HARDROCK
LUHR HOTEL
CENTRAL AVE AND MADISON STREET

SUPPLIER - ATLAS CONSTRUCTION SUPPLY, INC.
4640 BRINELL STREET
SAN DIEGO, CA 92111

CARUSO TURLEY SCOTT, INC. COUNSULTING ENGINEERS
☐ REVIEWED ☒ REVIEWED & NOTED
☐ REVISE & RESUBMIT

DRAWING TITLE:
TITLE PAGE

WALLFORM PLAN TYP. LVL 1-20

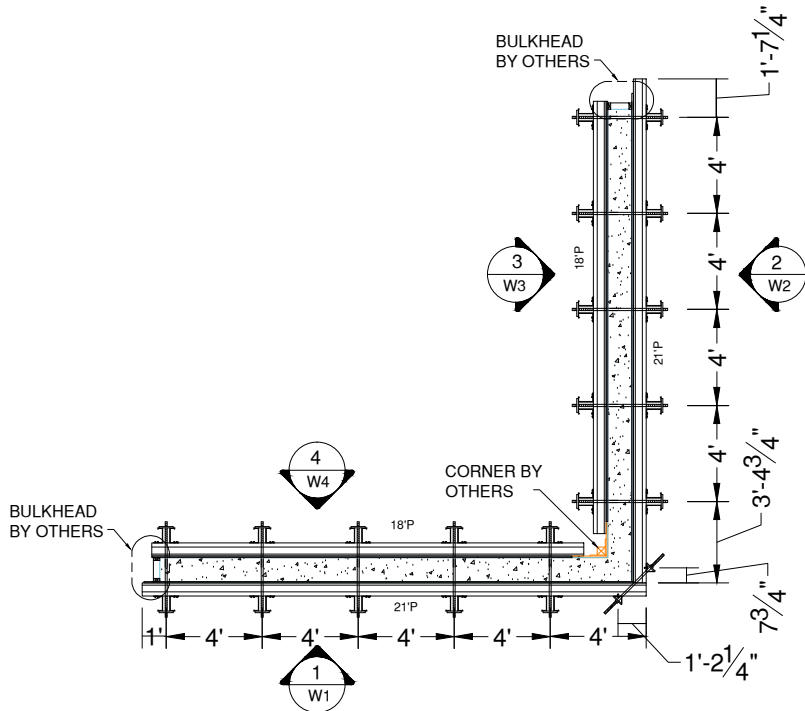
**** GC shall coordinate all wall thicknesses with structural drawings.
Wall thicknesses vary from 8", 12" and 16".**
